# **Technical Service Information**

### FORD CD4E

#### DIRECT CLUTCH STEEL PLATES CHANGE

Figure 1

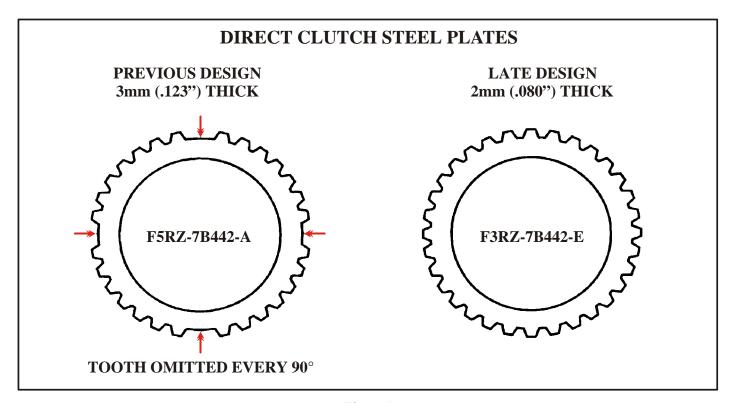
COMPLAINT: Beginning on March 1, 1996, all CD4E transaxles in 1996 Contour, Mystique and Probe

vehicles, equipped with the 2.OL engine, were assembled with thinner direct clutch steel

plates, as shown in Figure 1.

**CAUSE:** Incorporation of the direct clutch high energy friction material.

CORRECTION: (1) DIRECT CLUTCH STEEL PLATES - The thickness changes from .123" thick on the previous design level, to .080" thick on the new design level plates. The previous design level plates (. 123" Thick) are identified with a tooth omitted every 90 degrees, as shown in Figure 1. The best and most positive identification is to measure the thickness with a dial caliper.

If the direct clutch steel plates require replacement without replacing the clutch drum, identify the thickness of the steel plates being used by measuring with a dial caliper, and replace with the same thickness plates (See Figure 1).

Figure 2

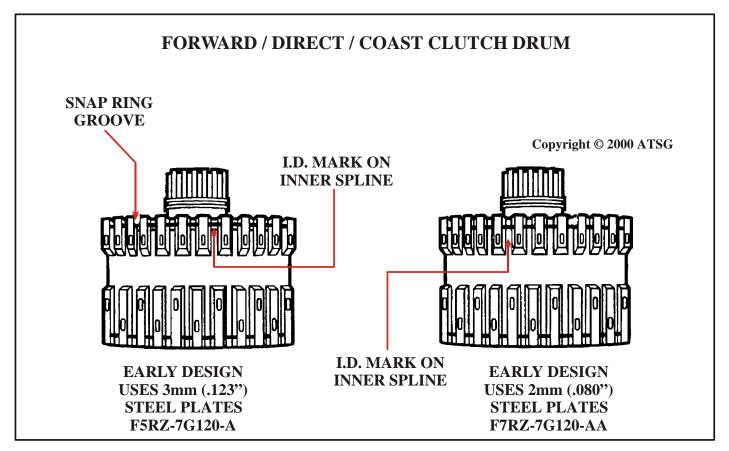
> (2) FORWARD/DIRECT/COAST CLUTCH DRUM - Changed because of relocation of the snap ring groove, to accommodate the thinner steel plates. The previous design level clutch drum that uses the .123" thick direct steel plates, can be identified by the mark on the inner splines just below the snap ring groove, as shown in Figure 2.

For 1995 Models, - when replacing the Forward/Direct/Coast Clutch Drum, use the previous

design level drum that requires the .123" thickness direct clutch steel plates. The .123" thick direct clutch steel plates are included in service package F5RZ-7G120-A.

For 1996 Models, - when replacing the Forward/Direct/Coast Clutch Drum, 'use the latest design level drum that requires the .080" thickness direct clutch steel plates, using OEM part number F7RZ-7G120-AA.
